ZONING AMENDMENT, PLANNING APPROVAL, PLANNED UNIT DEVELOPMENT, SUBDIVISION & SIDEWALK WAIVER STAFF REPORT Date: January 9, 2003

NAME Gulf Coast Asphalt Company

SUBDIVISION NAME GCAC Subdivision

SITE PLAN

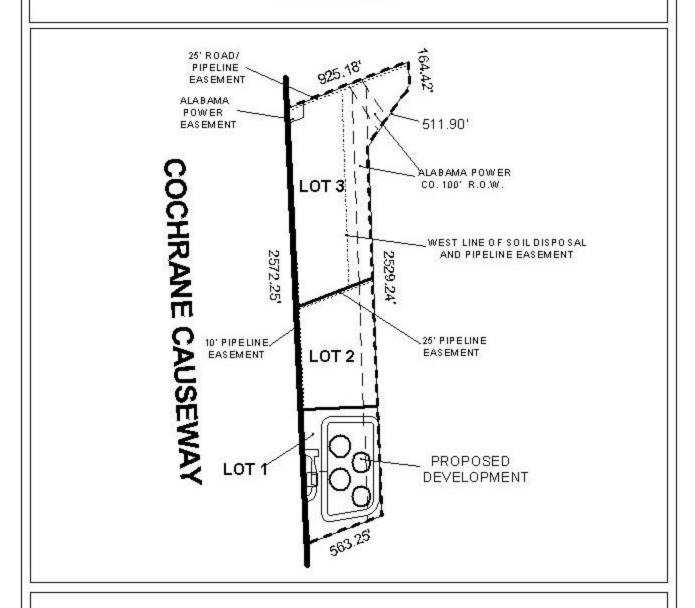
The site will be developed with four large tanks; and two curb cuts, with a small (five spaces) parking area also proposed. Regarding the parking and driveways, these areas

may be gravel, which is allowed by right in I-2 districts. Although the site adjoins R-1 property to the East, a buffer should not be required if and until the site to the East is developed residentially. Additionally, full compliance with the landscaping and tree planting requirements of the Ordinance would be required; however, in I-2 districts, only frontage trees are required.

In regard to the proposed subdivision, the site fronts a planned major street, which has an existing right-of-way in compliance with the Major Street Plan. However, access management is a concern, thus a note should be placed on the final plat stating that the number, location and design of all curb cuts shall be approved by the Traffic Engineering.

Subdivision: With modifications, the plat will meet the minimum requirements of the Subdivision Regulations and is recommended for Tentative Approval subject to the following conditions: 1) the approval of all necessary federal, state and local agencies prior to development; 2) provision of a buffer along the

East property line, at such time the adjacent property is developed residentially; and 3) placement of a note on the final plat stating that the number, location and design of all curb cuts shall be approved by Traffic Engineering.
